**Adelaide Avenue Environmental Justice Coalition  
60 Crescent Street  
Providence, Rhode Island 02907**

**Re: Textron's Park Parcel Remediation Plan  
Community Stake holder's Comments  
First Opportunity for Public Response**

# **Figure 1**

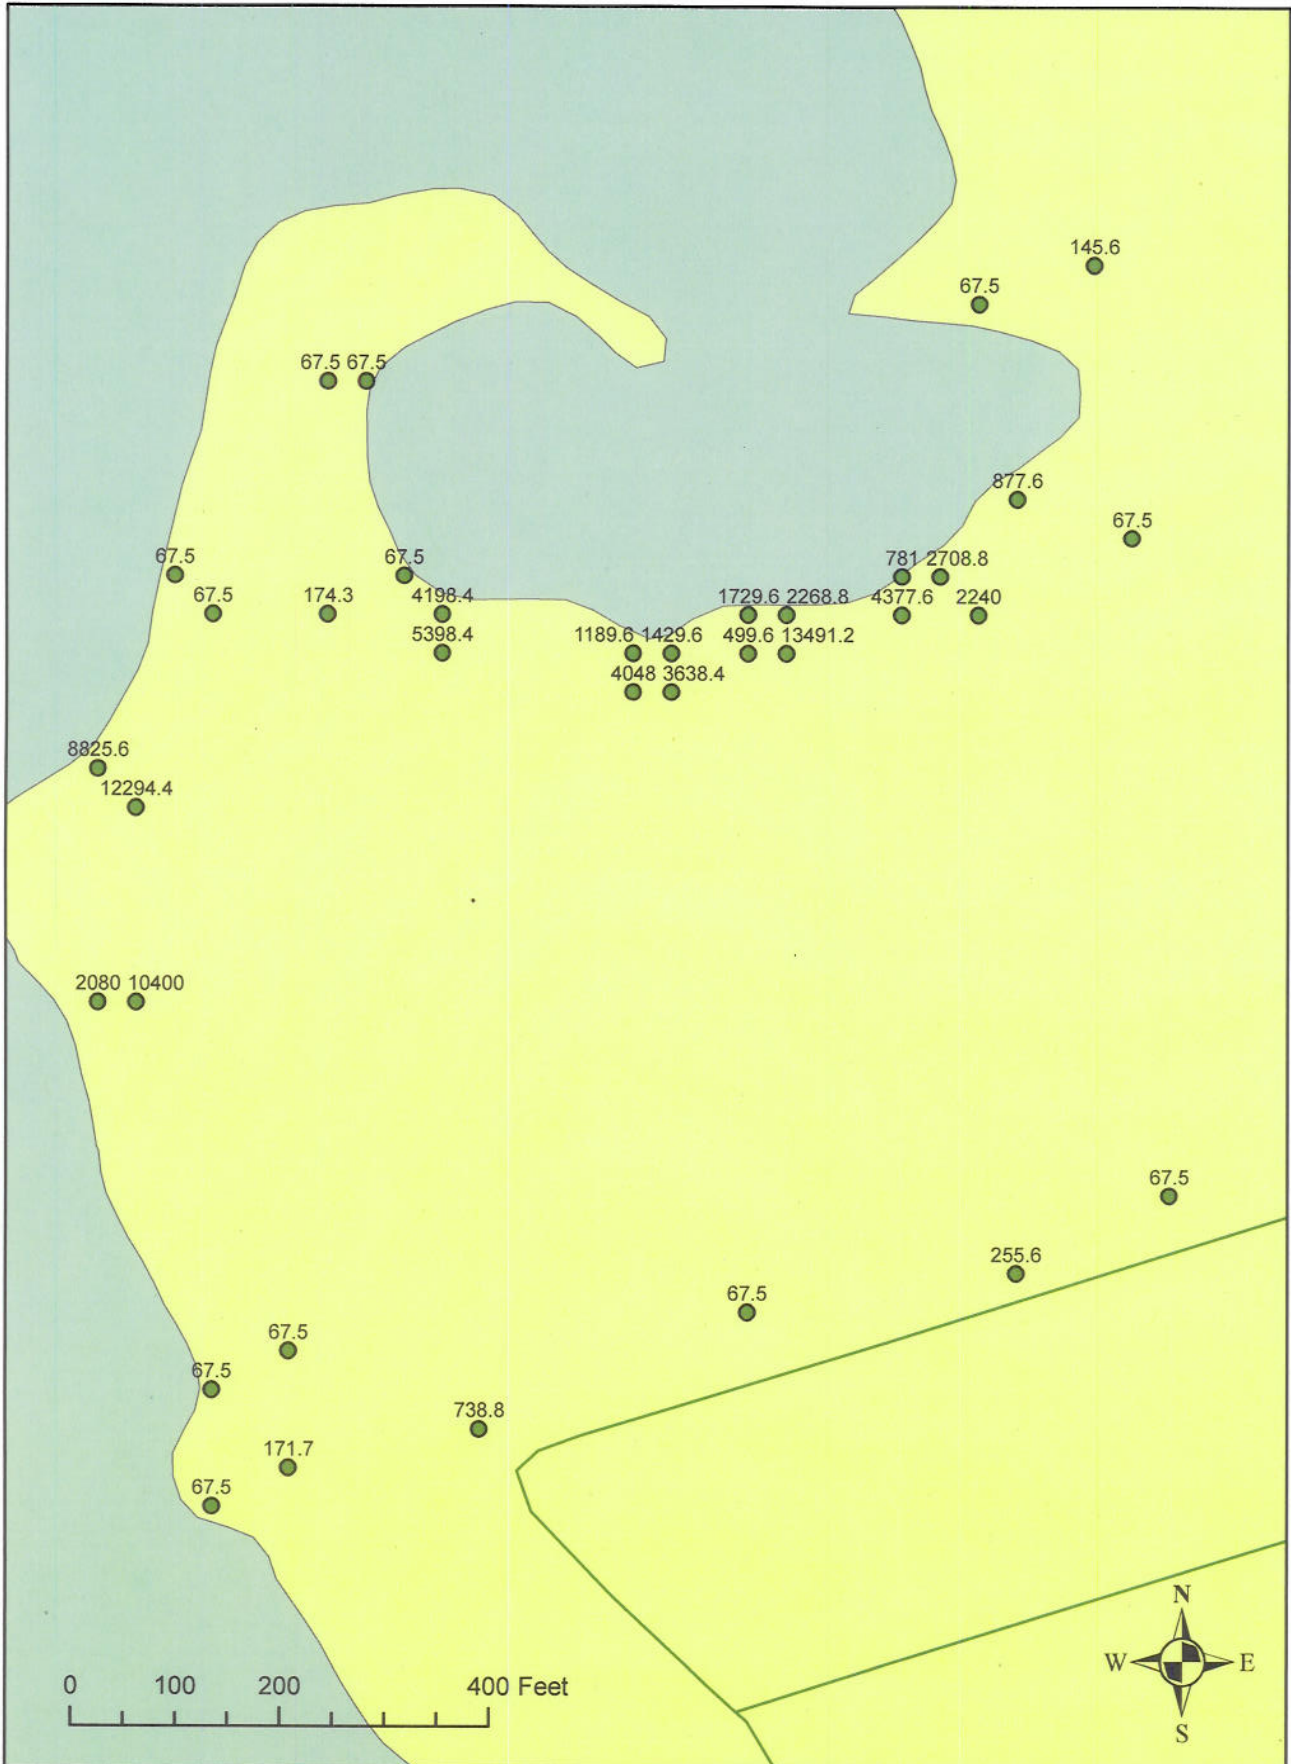
The fill area between Parcel B's rear property line and the edge of the present day shoreline of the Cove has not been defined accurately or adequately (see figure-1). All responsible parties, and stakeholders acknowledge that this section of the property has been used as a waste site and industrial dump. The issues that continue to be in dispute are the actual parameters of this impacted area, which the community believes have not been delineated clearly or properly. The analytical sampling data for the north bank of the fill area identifying what contaminants are present and in what concentrations is still incomplete. When Building V, a secondary copper smelter, was constructed in 1915 it was erected directly on the shoreline of the cove. Since that time a vast area along the entire north bank has been filled with the industrial waste and debris generated by the entire silver and bronze manufacturing facility. Much of the cove itself has been filled, moving the shoreline approximately one hundred and twenty feet (120') to the north and northwest (figure-2) We know and have reason to believe that a significant portion of fill area is below the water table along this quadrant of the north bank. This condition creates an opportunity for the groundwater flowing into the cove to move directly through a large area of impacted fill material. It is inconceivable to the community that the RIDEM would not insist on a complete characterization of this fill area and all its contaminants prior to approval for capping, after which Textron and the City will never return to these potential issues, regardless of the RIDEM's or the community's position.

We are requesting that Textron extract a series of soil borings from within the fill area surrounding the cove, at a depth of at least twelve (12) feet below the water table. Ideally these samples would profile the horizontal and vertical distribution of VOCs in the industrial waste and fill of the north bank and southern shore of the cove; within the groundwater zone and above. Soil samples would be collected every foot in depth until reaching the bottom of the industrial waste or soil deposited along the south edge of the cove. After recovering these initial samples, the borings could be continued to depth to help delineate the activity at the shallow and deeper aquifer, if any. Please utilize the EPA Method 5035 for collection of soil boring samples. The objective of this particular test is to minimize VOC loss from volatilization and biodegradation during sampling collection and handling. The community is requesting that Textron and their contractors collect at a minimum sixteen (16) soil boring samples from the area designated in figure-2, and sample for a complete suite of analytes.
